# ADDENDUM

**ADDENDUM NO.:** 001  
**PROJECT NAME:** CANTY ELEMENTARY SCHOOL ANNEX  
**PROJECT NO.:** 05750  
**CONTRACT NO.:** C1568  
**DATE OF ISSUE:** May 28, 2015

## NOTICE OF CHANGES, MODIFICATIONS, OR CLARIFICATIONS TO CONTRACT DOCUMENTS

Sheet M.202a

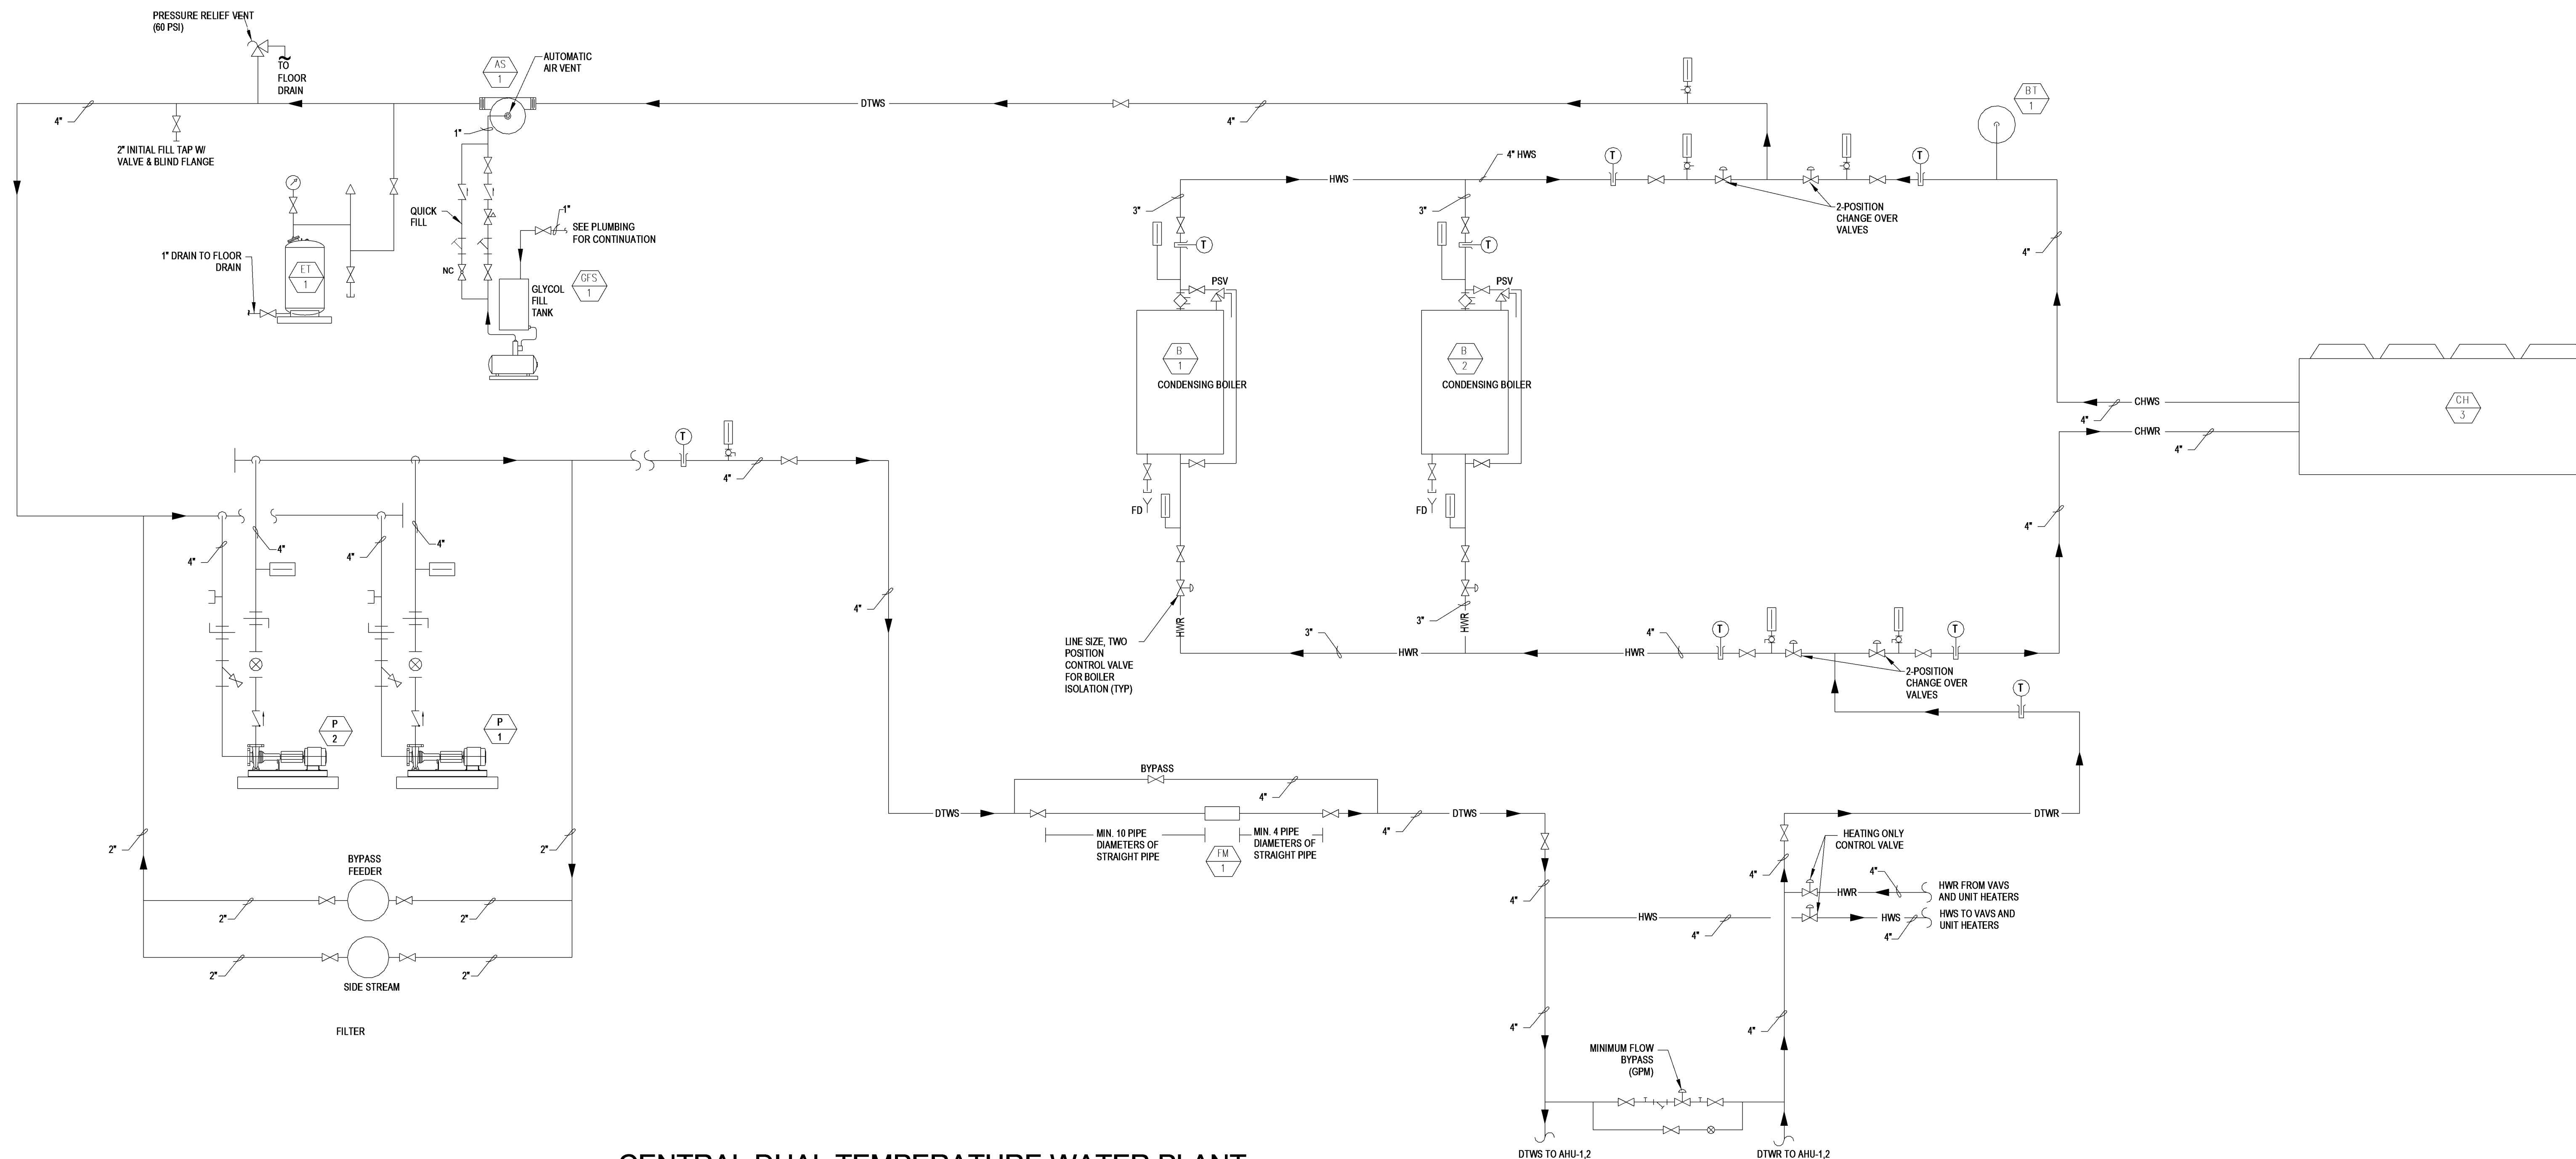
- a. Ductwork For VAV2-12B Revised
  - b. Ductwork to KEF-1 has been revised for updated airflow
  - c. Ductwork to EF-3 has been revised for updated airflow

- d. Ductwork to EF-2 and from L-1 has been revised
- 13. Sheet M.203a Roof Area A - Partial Mechanical Ductwork Plan
  - a. Added keynote 1 "PROVIDE MINIMUM 12" DUCT EXTENSION BETWEEN OUTSIDE AIR INTAKE DAMPER AND INTAKE HOOD FOR INSTALLATION OF AIR FLOW 1 MEASURING STATION"

Sheet  
**M.400**

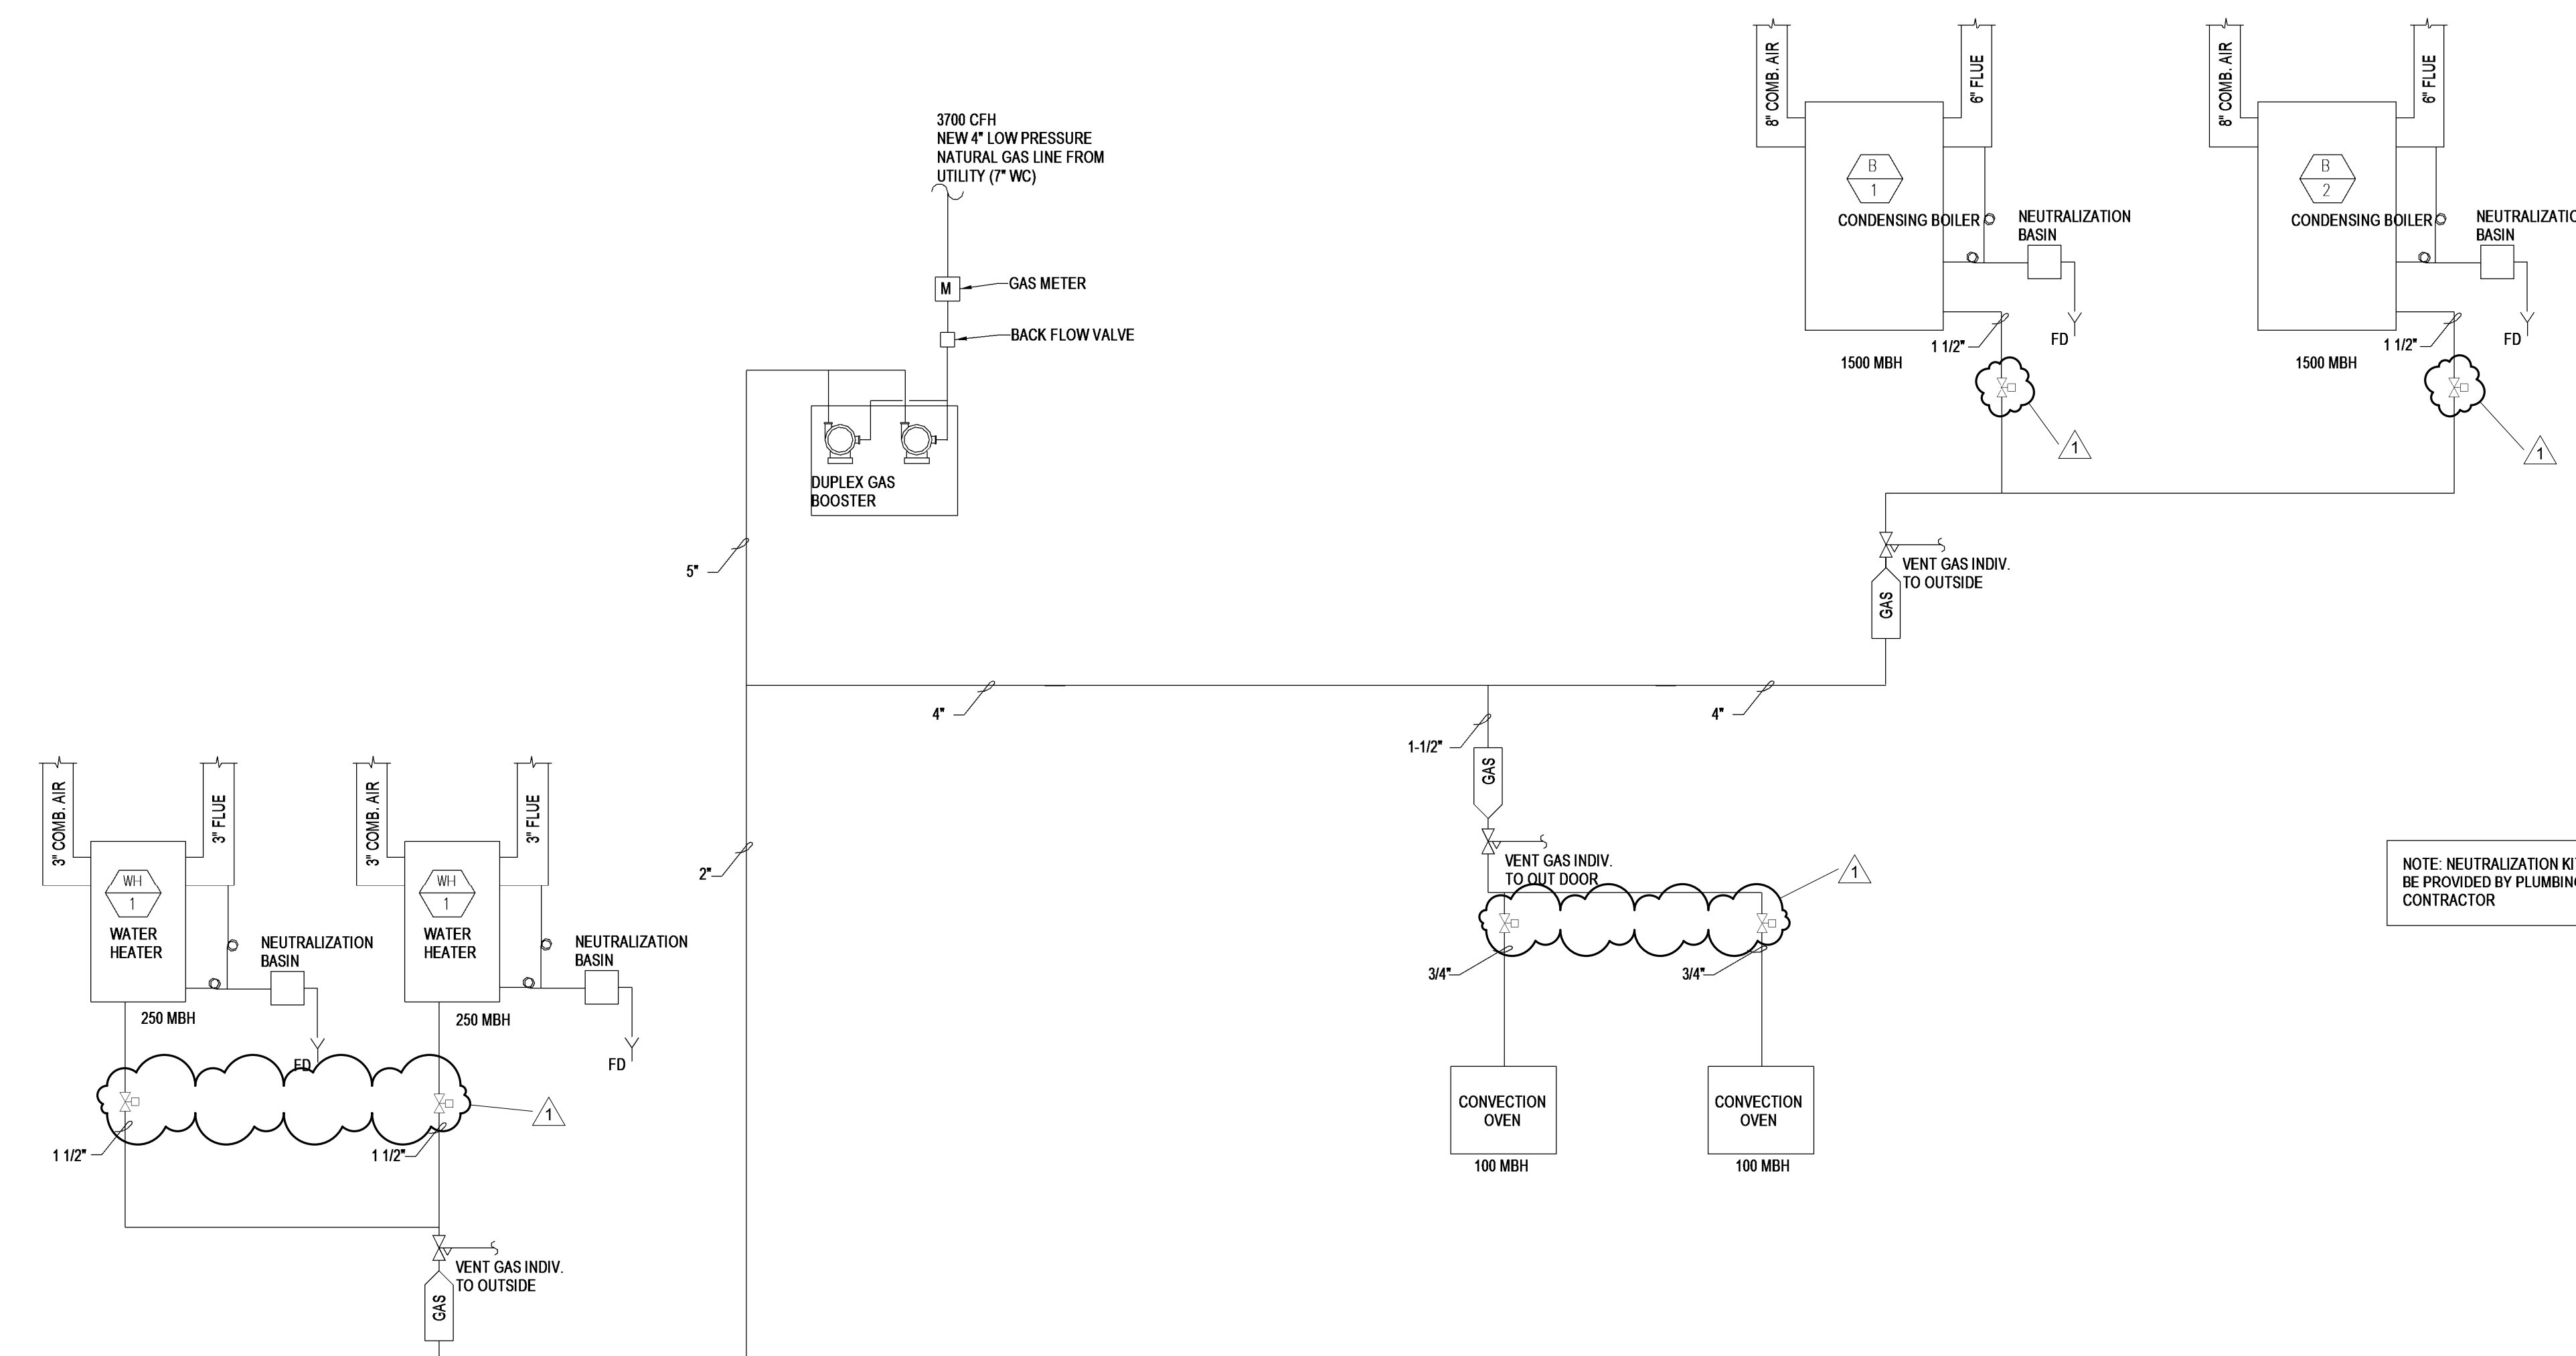
- a. Revised valves on gas riser diagram
- 19. Sheet M.500 Mechanical Schedules
  - a. Revised EF-2,3,4 on Fan schedule
  - b. Revised AHU schedule
  - c. Revised AHU filter data

13 VERTICAL HOT WATER UNIT HEATER PIPING DIAGRAM NTS

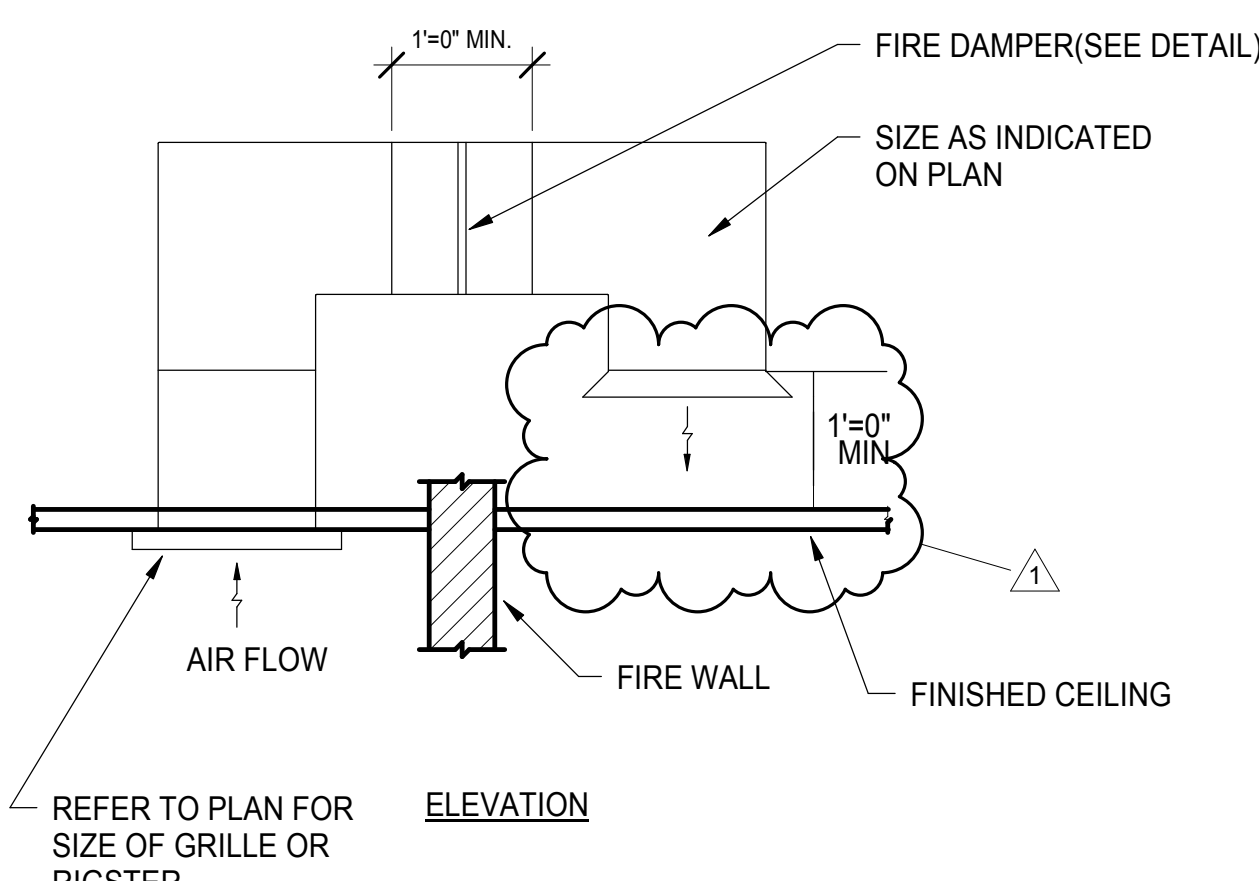
- b. Detail 12 has been removed
  - c. Detail 9 has been revised
  - d. Detail 11 has been revised
  - e. Detail 13 has been revised
- 24. Sheet M.604 Mechanical Details
